### **ITEM FOR ENVIRONMENTAL COMMISSION AGENDA**

<b>COMMITTEE MEETING DATE:</b>	March 6, 2024
<b>NAME &amp; NUMBER OF PROJECT:</b>	311-315 South Congress PUD, C814-2023-0027
<b>NAME OF APPLICANT OR ORGANIZATION:</b>	Drenner Group (Amanda Swor)
<b>LOCATION:</b>	311 South Congress Avenue
<b>COUNCIL DISTRICT:</b>	9
<b>ENVIRONMENTAL REVIEW STAFF:</b>	Leslie Lilly, Environmental Conservation Program Manager, (512)535-8914, Leslie.lilly@austintexas.gov
<b>WATERSHED:</b>	Lady Bird Lake & East Bouldin Creek Watersheds
<b>REQUEST:</b>	Planned Unit Development
<b>STAFF RECOMMENDATION:</b>	Staff recommended with conditions.
<b>STAFF CONDITION:</b>	Development associated with C814-2023-0027, located at 311 S. Congress Ave, shall comply with the following requirements. <ol style="list-style-type: none"><li>The PUD will comply with the City of Austin's Green Building Program at a 3-star level.</li><li>The project will be compliant with the LEED pilot Bird Collision Deterrence credit in regard to the Bird Collision Threat Rating for reflective glass within the Façade Zone 1 area as defined by LEED. Façade Zone 1 shall not have greater than 15% reflective glass</li><li>The project does not reques

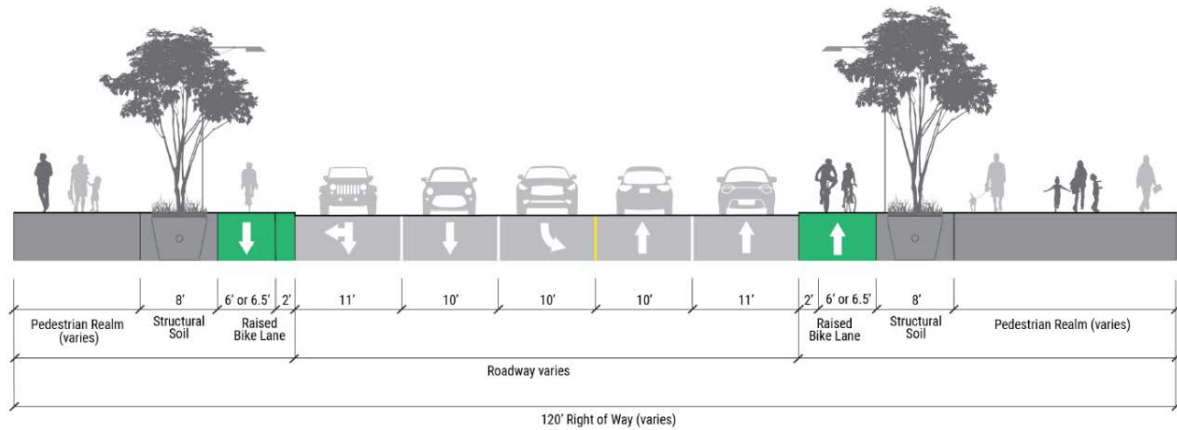
ATD 7. ATD does not recommend approval of this proposed language of Land Use Plan note #8 (noted above). To provide superiority for the streetscape, we request that the site adhere to the streetscape standards as depicted within the proposed in the South Central Waterfront Plan:

S. Congress: The South Central Waterfront plan calls for a 6’-6.5’ raised bike lane behind a 2’ buffer along the east frontage of S. Congress. The ASMP identifies protected bicycle facility along Congress frontage as well. In order to meet the superior results expected from PUDs, the cross sections should at least meet the baseline set by ASMP.

**U1: Comment cleared.**

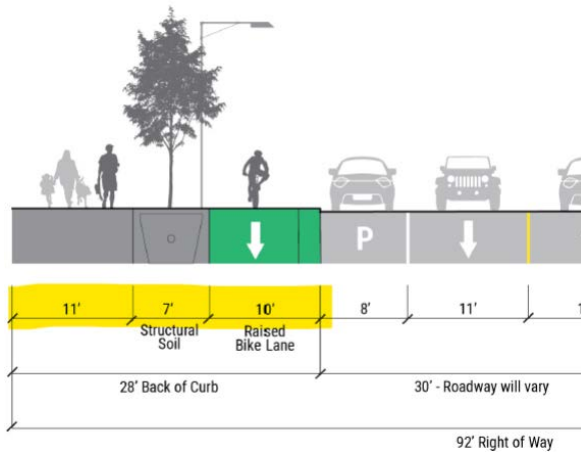
Barton Springs Road: The South-Central Waterfront plan calls for an 11' pedestrian zone and 8' planting zone, adjacent to an 8' raised bike lane behind a 2' buffer along the southwest frontage of the Barton Springs Road extension. In order to meet the superior results expected from PUDs, the site's frontage along the Barton Springs extension should provide these streetscape elements as depicted below:
